Re: **Rialto Village** **MDP # 026-06**

The City Staff Development Review Committee has reviewed Rialto Village Master Development Plan **MDP # 026-06**. Please find enclosed a signed copy for your files. Your plan was approved for acceptance, however please note the following:

RIALTO VILLAGE

MASTER DEVELOPMENT PLAN/PLANNED UNIT DEVELOPEMENT

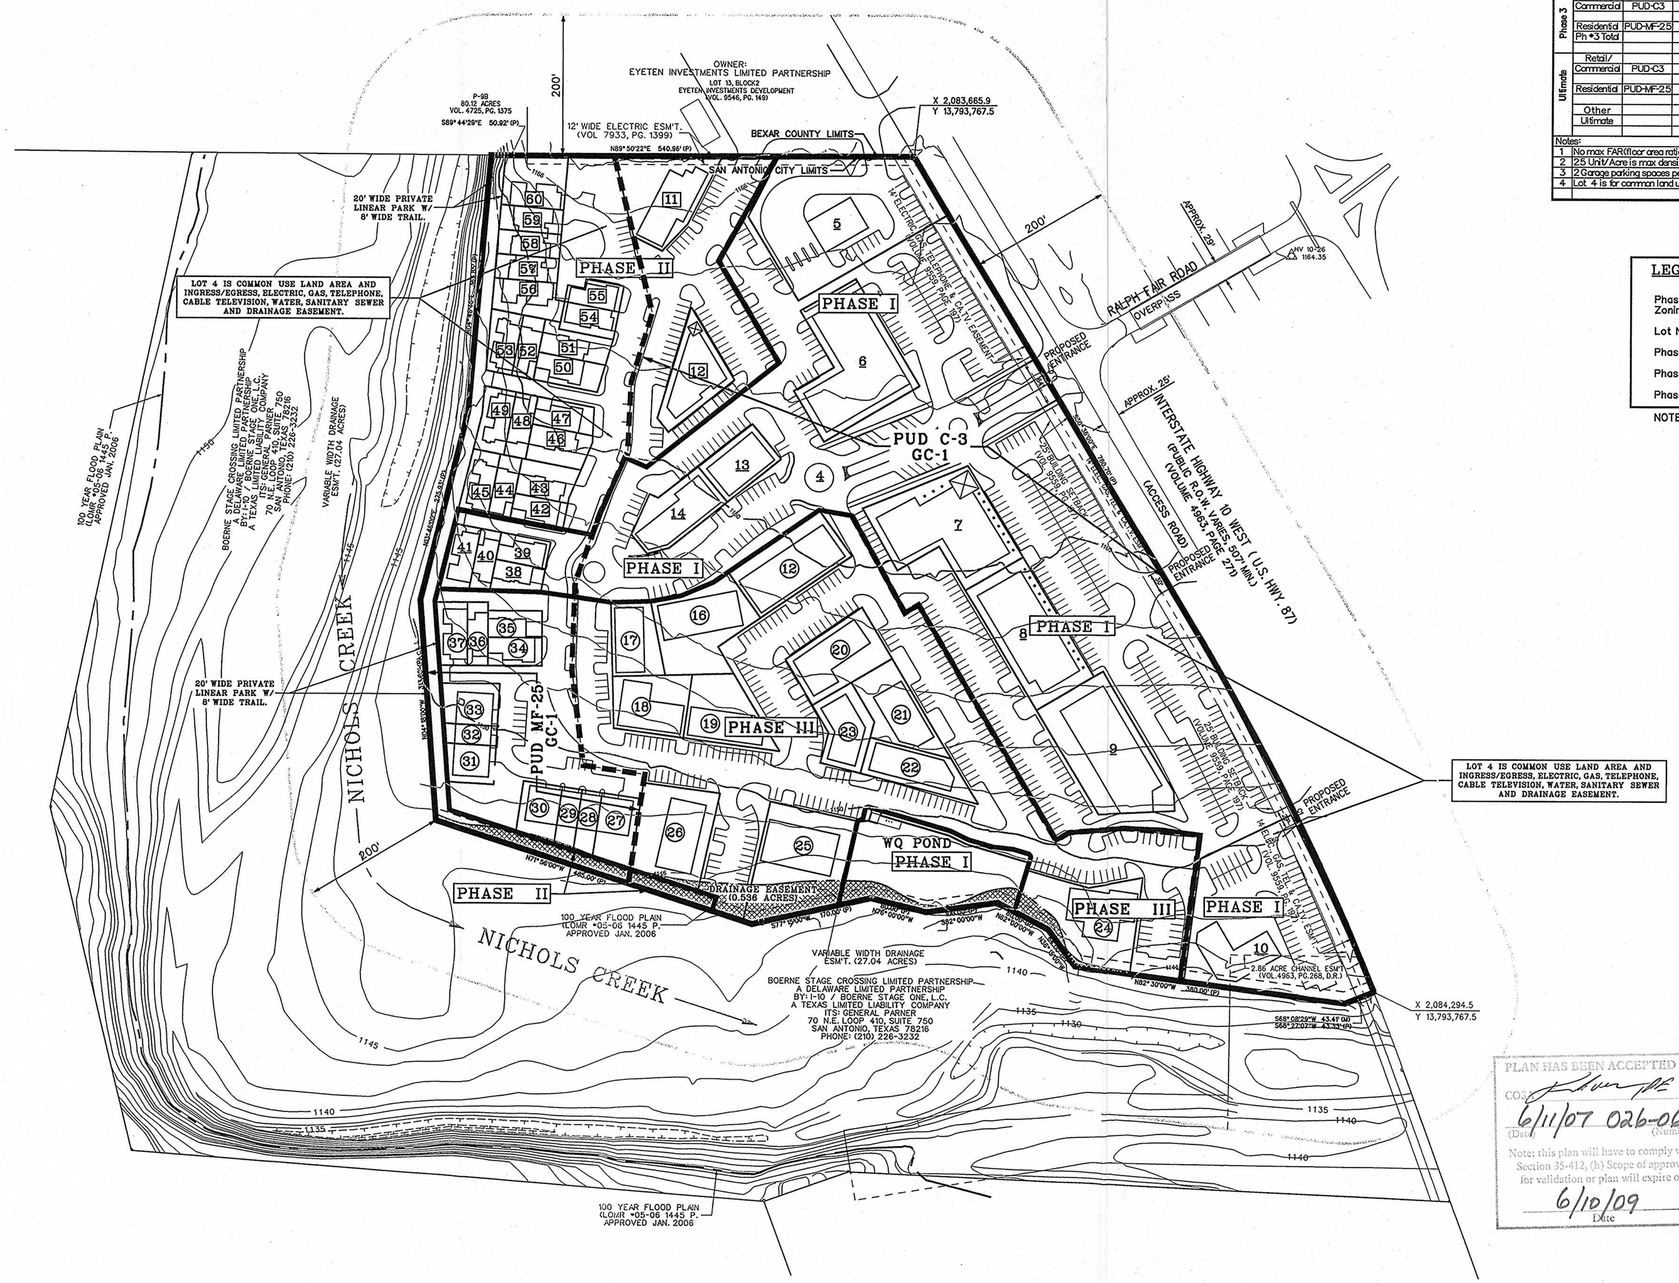
In consideration of public safety and convenience, excessive grades by reason of topography should be avoided in street layouts and arrangements. Any access and R.O.W. issues along state facilities will need to be resolved with the **Texas Department of Transportation (TXDOT)**. For information about these requirements you can contact TXDOT at 615-5814.

Historic Preservation states the following: The Texas Sites Atlas indicates that archaeological sites have been previously identified within or nearby the above referenced property. Also, the property may contain historical architectural sites, some of which may be significant. Thus, before any work that might affect any sites is begun, we recommend that qualified professionals conduct an archaeological and historical structures investigation of the property. The investigations should be performed according to Archeological Survey Standards for Texas, and previously identified sites should be reexamined and reevaluated, if any. The Council of Texas Archeologists provides a list of qualified consultants that can be accessed on-line at www.c-tx-arch.org, The consultant will probably need to obtain an antiquities permit from the SHPO prior to starting the investigation. A report of findings should be prepared according to the Council of Texas Archeologists [CTA] Guidelines for Cultural Resource Management Reports and submitted to the HPO and SHPO for review. Copies of the survey standards, the CTA guidelines, and a list of qualified consultants may be obtained by calling the SHPO at 512-463-6096 or writing to P.O. Box 12276, Austin, Texas 78711-2276. Any part of the property investigated since June 1, 2006 may be omitted and the report for the previous study may be submitted for that area. Law allows both the HPO and SHPO 30 days from receipt for reviews.

SAWS Aquifer Protection and Evaluation will require the following pursuant to the Aquifer Protection Ordinance No. 81491:

- 100 year Flood Plain shown and buffering (If applicable)
- Significant recharge features and buffering (If applicable)
- Category letter for all site specific plats (If Category 2 or 3, an Aquifer Protection Plan is required (If applicable)
- Additionally, a Water Pollution Abatement Plan or Contributing Zone Plan must be submitted to and approved by the Texas Commission on Environmental Quality (TCEQ) prior to construction.

- 2006 Tree Preservation ordinance standards per UDC Section 35-523 – a Tree Preservation Plan is required prior to any work on site. This can be submitted either as a site work permit or at the platting stage. Additional permitting fees and affidavits will be needed to obtain tree permits during the platting and/or building permit stages. This project appears to be suited to a Tree Stand Delineation (30% preservation of tree canopy at MDP or 35% preservation at platting) based on the large lot sizes and tree canopy area. Note that flood plain area must be delineated separately (preserved at 80% for significant trees and 100% for heritage trees).

- Landscape ordinance per UDC Section 35-511. It appears all landscape points can be met by preserving existing vegetation as well as meeting any mitigation requirements (either through preservation of smaller material or transplanting). Recommend securing knowledgeable Landscape Architect at planning and design phase to better utilize existing trees and vegetation. Preservation will eliminate the need for irrigation. Staff would be willing to meet with developer at design stage to assist with tree preservation and landscape plan.

- The parkland provided shall be shown as "Park" or "Open Space" on a plat; UDC sections 35-503(e) *Designation of Parkland.*
- The parkland provided is dedicated to the Home Owners Association.
- The instruments creating the Home Owners Association are provided by the second application for plat approval; UDC sections 35-503(e) *Designation of Parkland.*

- Parkland dedication must be platted by the second phase of residential development; UDC section 35-503(f) *Development Phasing*.
